From: [REDACTED]
Sent: Friday, February 12, 2021 3:00 PM
To: [REDACTED]
Subject: RE: F-150/SuperDuty Post FSA UTGO EDS Issue Review

Subject: RE: P558 Tailgate Harness Configuration

Subject: P558 Tailgate Harness Configuration

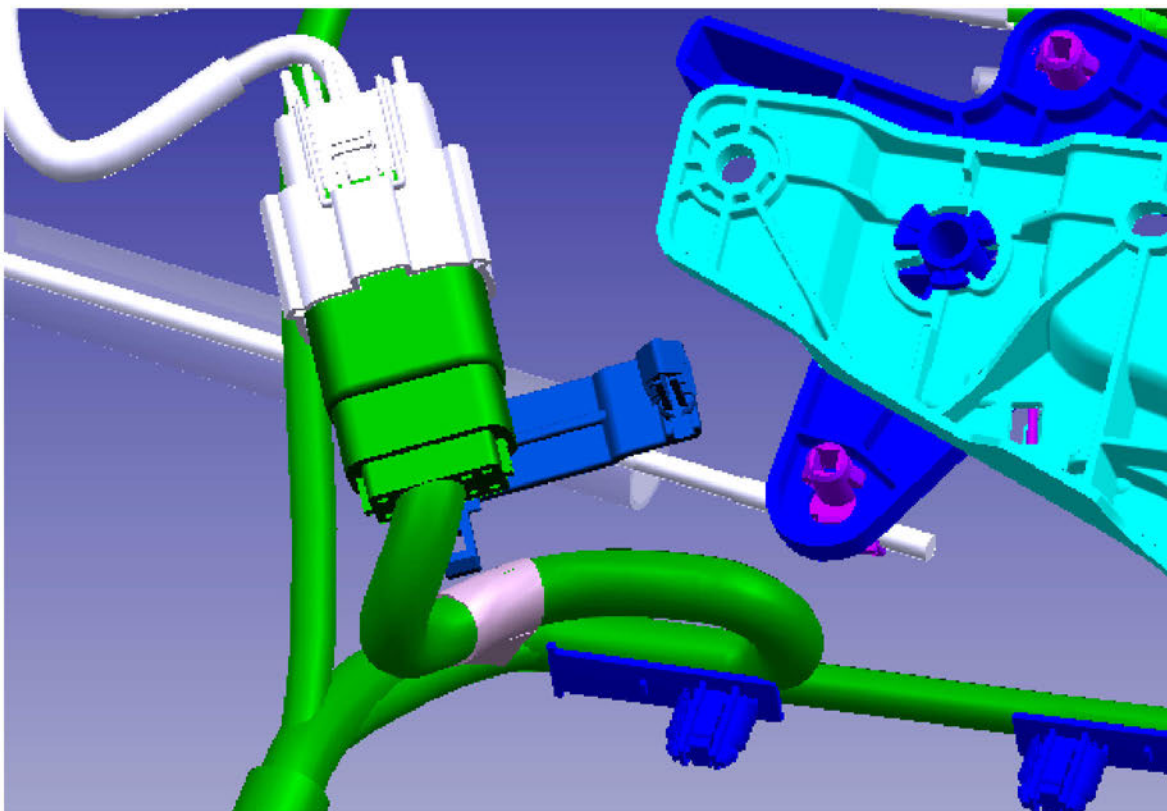
What about the harness I made yellow? It looks like it overlaps with the other harness. Are they both present at the same time?

The bundle you made yellow is the option for A7EAB (Manual tailgate lock)

Brainplate P/N: HC3B-99431F94-B* (Manual locking and manual release)

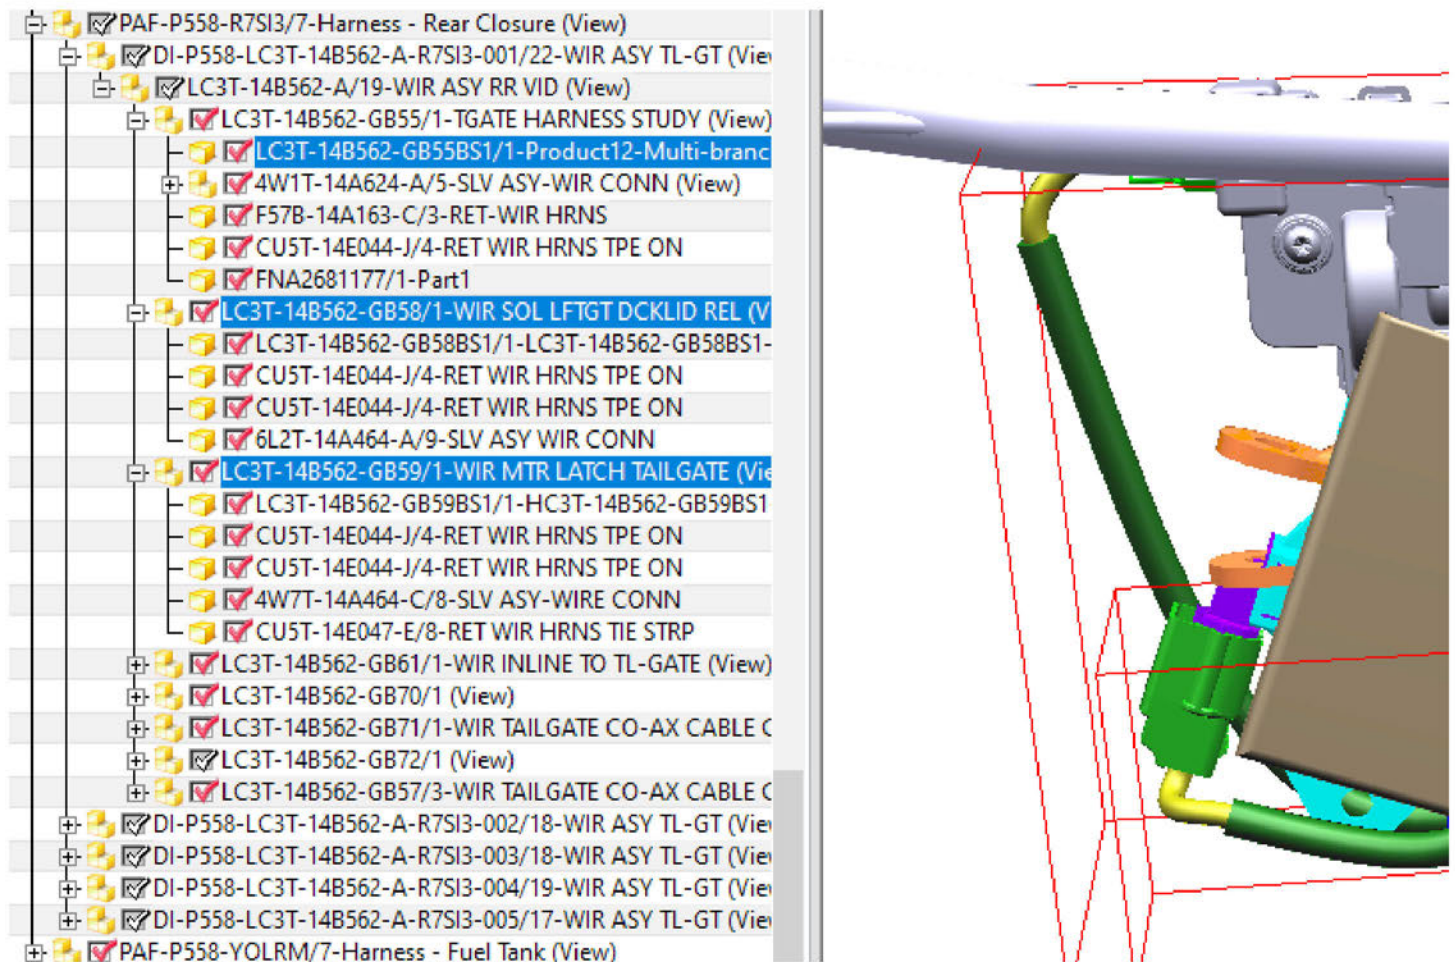
As you may know, there are (3) brainplates in the P558 tailgate latching system. I've noticed that some of the brainplates have a very close condition to the harness, however I'm not sure if the harness is actually present for that vehicle configuration or if that harness is just shown across all CAD models.

Could you please confirm which harness configurations (Harnesses in question are shown highlighted below) are present for different tailgate configurations?

MIDWAY WIRE HARNESS COMPARISON: 17MY vs. 20MY

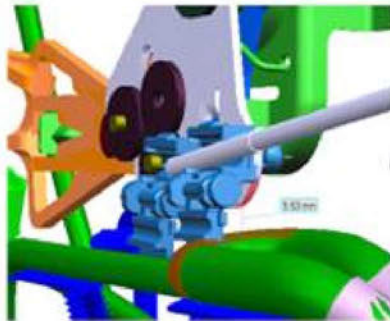
BP Housing Lever to Harness: ~5.63mm clearance

BP Housing Lever to Harness: ~5.8mm clearance
